Community Solar Project Interconnection
Community Solar Project Tier 2 Review

OCS095

Proposed Interconnection
On PacifiCorp’s Existing
Circuit 5L44 out of Hornet Substation

August 22, 2024

Figure 1: Simplified one-line diagram

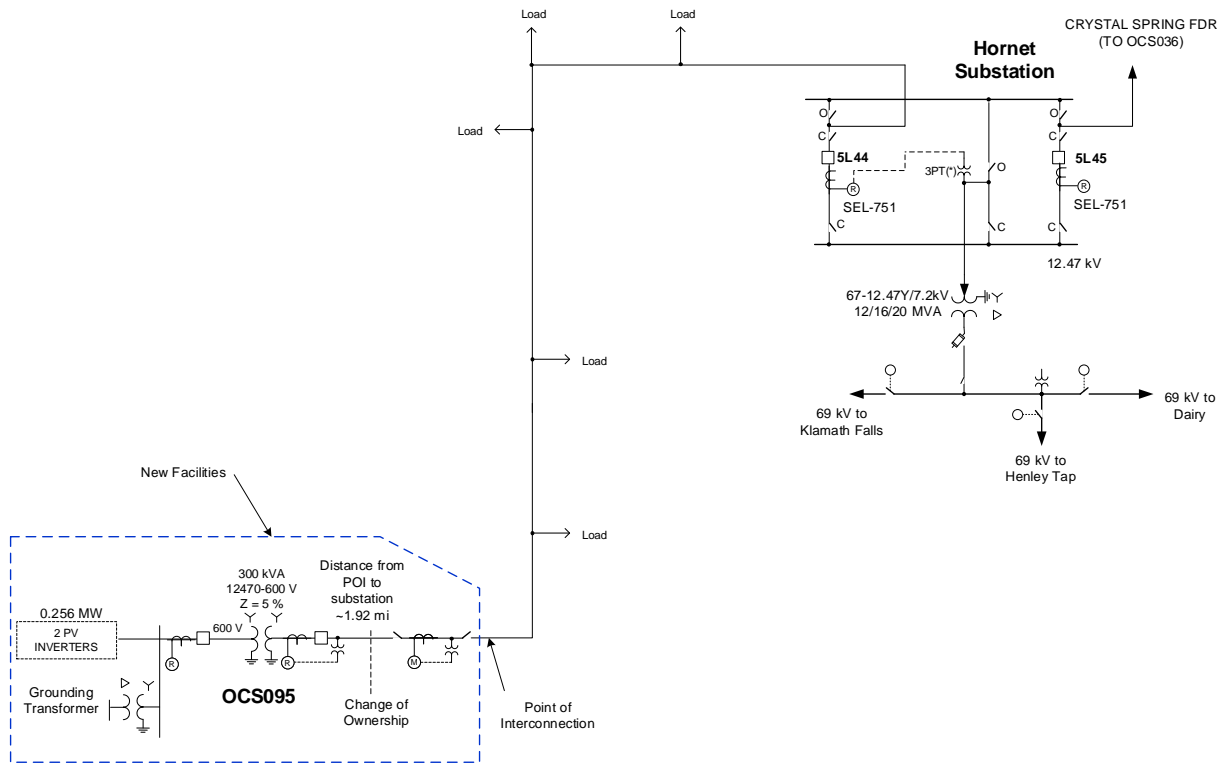
The Applicant’s proposed Community Solar Project is to be interconnected to the Public Utility’s distribution circuit 5L44 out of Hornet substation in Klamath County, Oregon. Figure 1 below is a one line diagram that illustrates the interconnection of the proposed generating facility to the Public Utility’s system.
